February 7, 2025

Re: **Corrective Measures Work Plan**
Info Tech High School
21-16 44th Road, Long Island City, NY 11101
NYSDEC VCP Site Number V00366-2

Re: Site Management (SM) Periodic Review Report (PRR) Response Letter
21-16 44th Road, LIC
Site No.: V00366

Figure 1

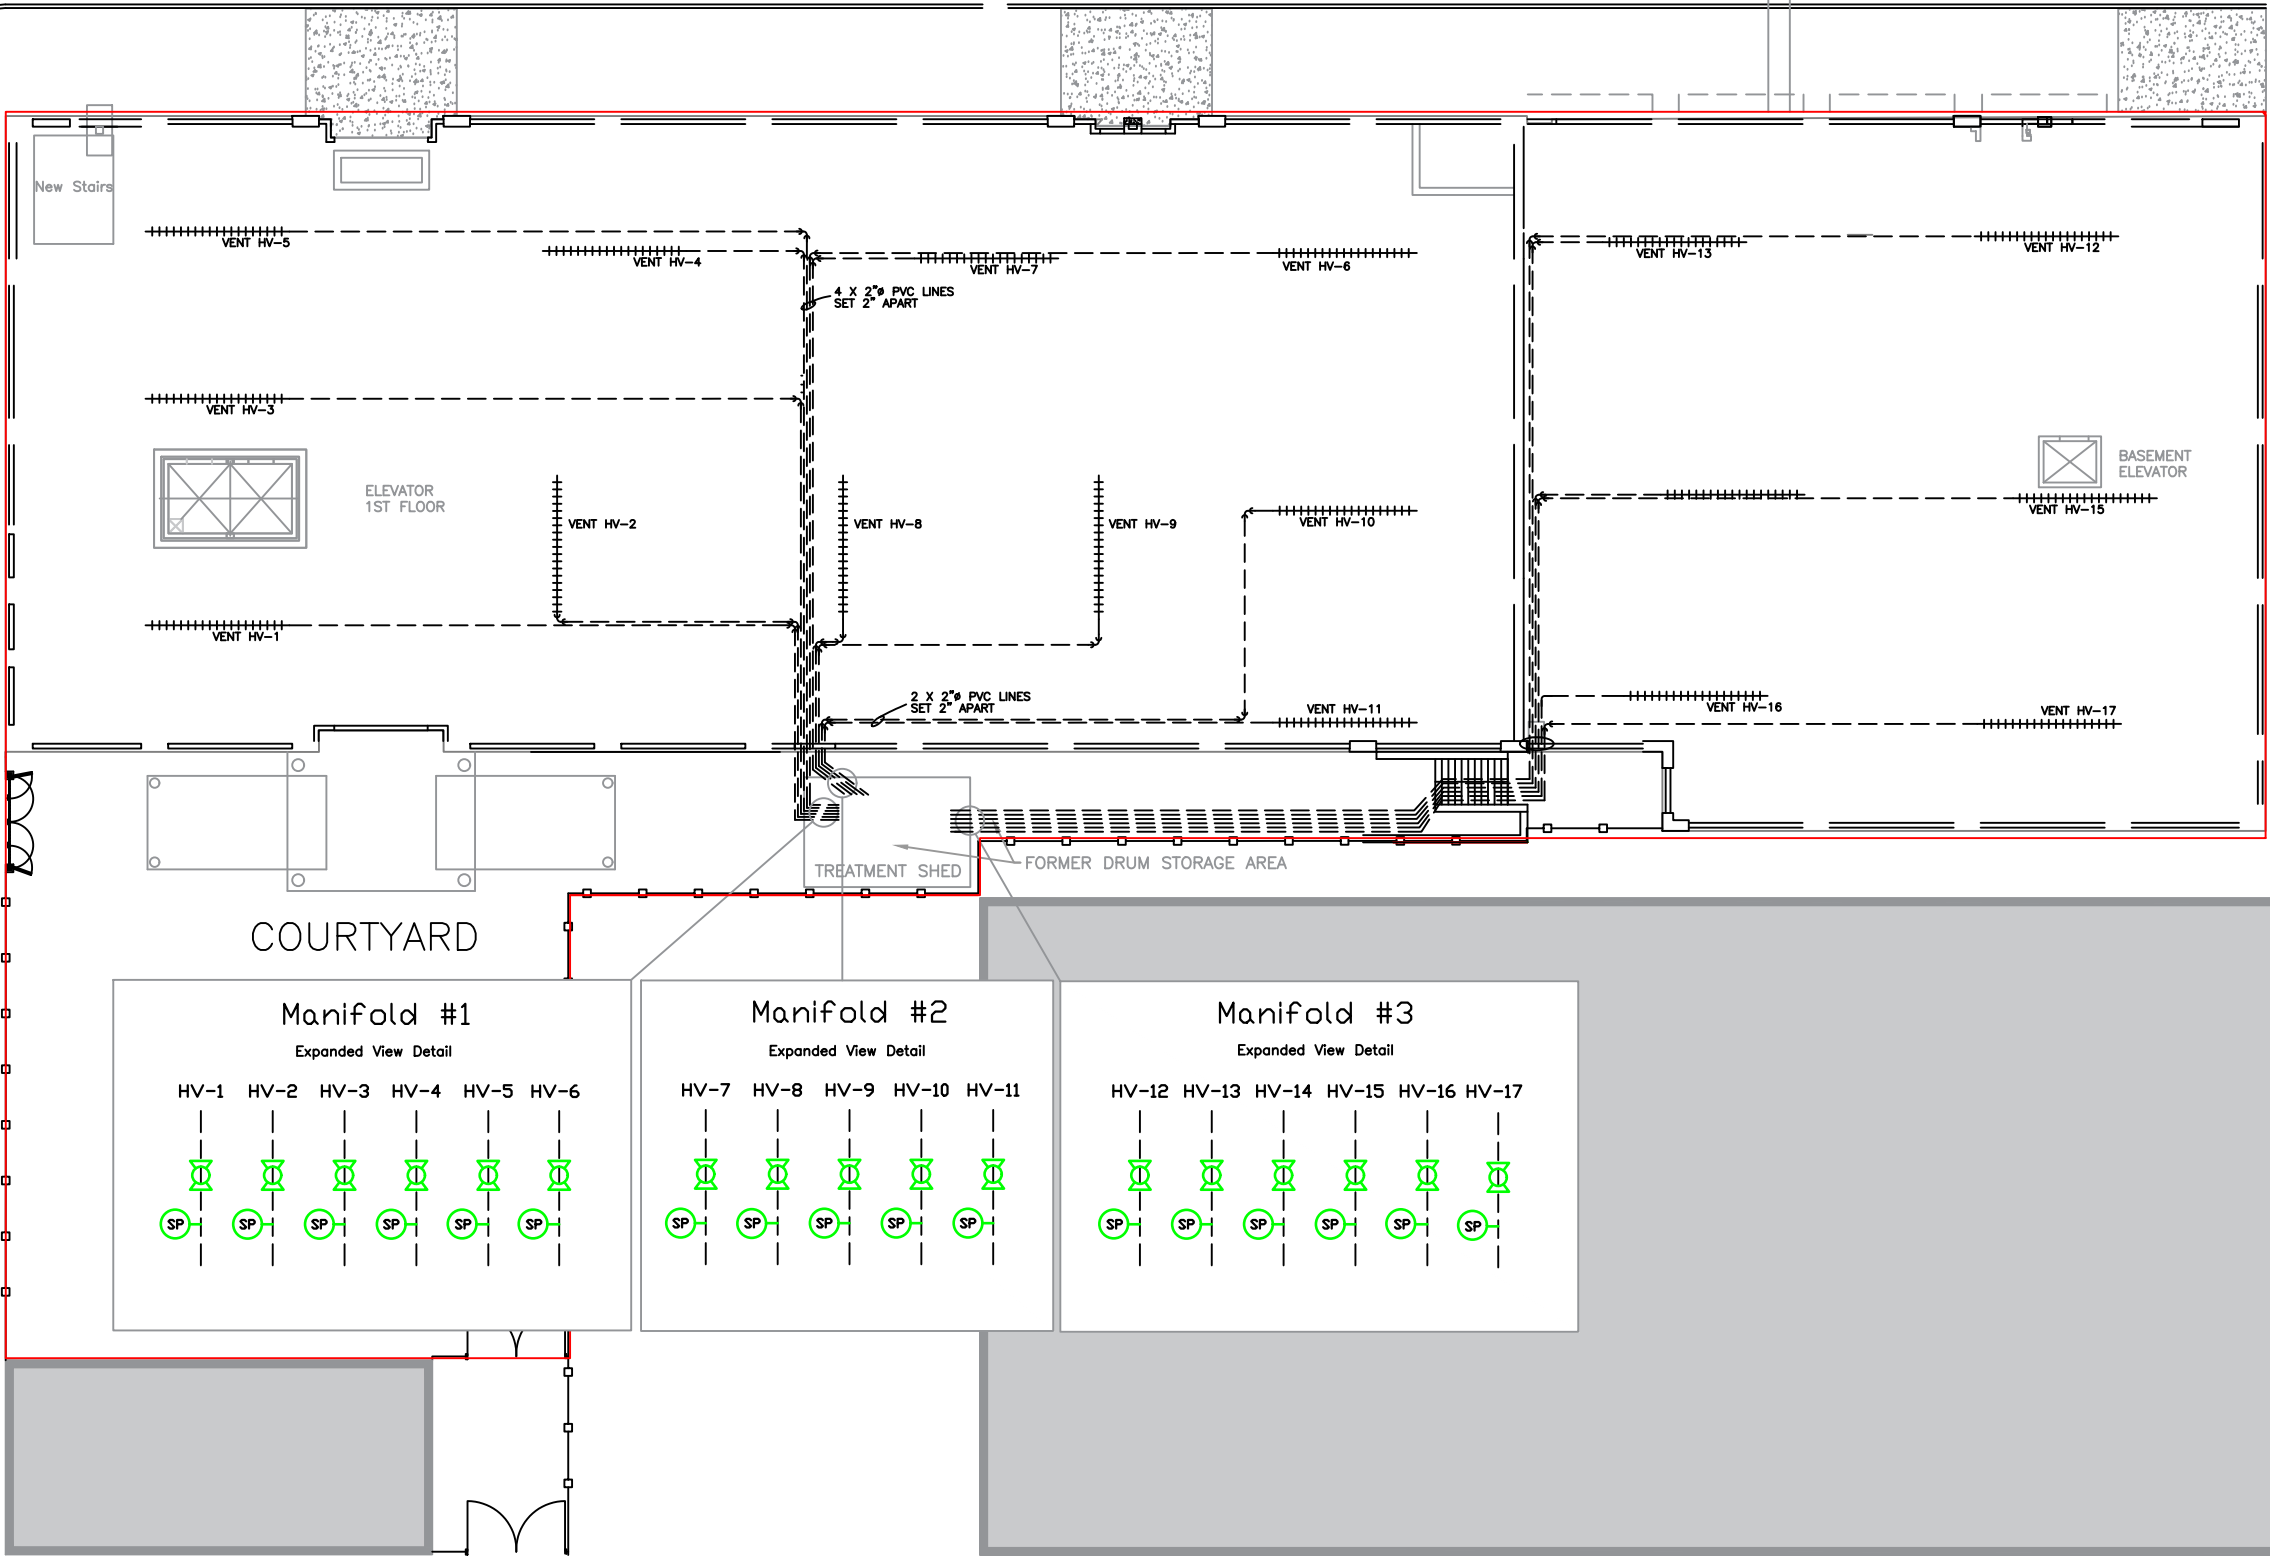
- The PRR refers to sub-slab soil vapor concentrations monitored through the sampling of the Sub-Slab Depressurization System (SSDS) effluent. This is not an accurate method of monitoring sub-slab soil vapor concentrations. To monitor sub-slab soil vapor concentrations, representative sub-slab soil vapor samples must be collected with Summa canisters at vapor monitoring points located throughout the building.

Following a discussion between NYSDEC and NYSDOH on January 14, 2025, it was determined that collection of soil vapor samples from the lateral sampling ports was not necessary to establish efficacy of the SSDS, and that semi-annual inspections of the SSDS should continue without change, per the approved SMP. Semi-Annual sub-slab monitoring events are currently conducted in 1st and 3rd Quarters each year. Per the SMP, and its subsequent revisions, monitoring of the SSDS will consist of a visual inspection of the complete system as currently constructed, including collection of a pressure reading, flow rate, temperature, and screening of sub-slab vapors with a Photoionization Detector (PID) at each individual SSDS lateral sample port. FLS has complied with the monitoring of the SSDS during semi-annual events, as outlined in the SMP. Readings from the 2023 reporting year are presented as Attachment 2. A layout of the SSDS is provided in Figure 1.

In addition to sub-slab monitoring, FLS will continue to collect an effluent sample to monitor emissions from the SSDS. The sample will be collected in a pre-cleaned laboratory certified Summa canister equipped with flow regulator set to collect the sample at a rate not to exceed 0.2 L/min. All sub-slab soil vapor samples will be collected simultaneously for a maximum duration of two (2) hours. Sample will be shipped under proper chain of custody protocol via courier to a New York State ELAP-certified laboratory. The sample will be analyzed for Volatile Organic Compounds (VOCs) via EPA Method TO-15. Following sampling, FLS will report the results of each sampling event in the annual PRR.

Figure 2

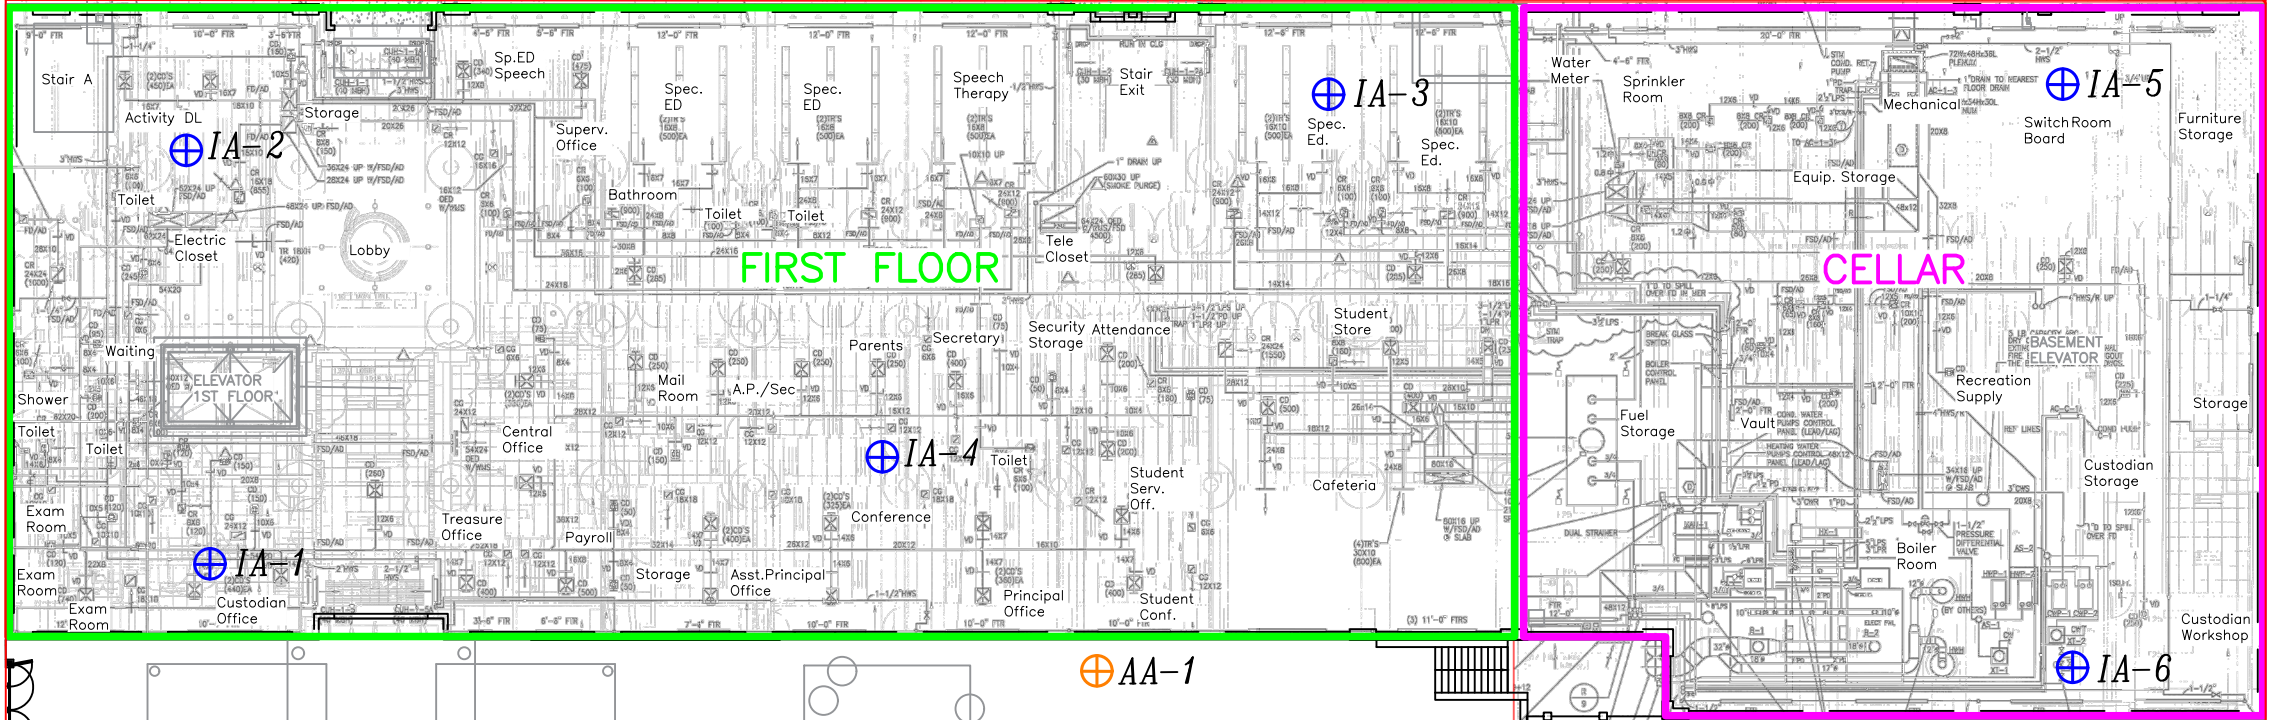
- It does not appear that indoor air monitoring has occurred in the school building, as required by the Site Management Plan (SMP). Indoor air sampling must be conducted during the 2024-2025 heating season, and annually thereafter, to evaluate the effectiveness of the SSDS. During the annual indoor air sampling, pressure field extension testing must be completed to ensure that the entirety of the slab of the building is depressurized. Lastly, please explain why indoor air sampling and pressure field extension testing has not been conducted in accordance with the SMP.

Based on the area of the Site, FLS proposes to collect six (6) indoor air samples. Two (2) indoor air samples will be collected at the cellar level of the building, and four (4) samples will be collected on the first floor in the slab on grade area of the building (Figure 2). In addition to indoor air samples, an ambient air sample will be collected as a control sample. All samples will be collected in pre-cleaned laboratory certified Summa canisters equipped with flow regulators set to collect the sample at a rate not to exceed 0.2 L/min. All indoor air and ambient air samples will be collected simultaneously for a maximum duration of eight (8) hours to simulate school hours. All indoor and ambient air samples will be shipped under proper chain of custody protocol via courier to a New York State ELAP-certified laboratory. All samples will be analyzed for Volatile Organic Compounds (VOCs) via EPA Method TO-15.
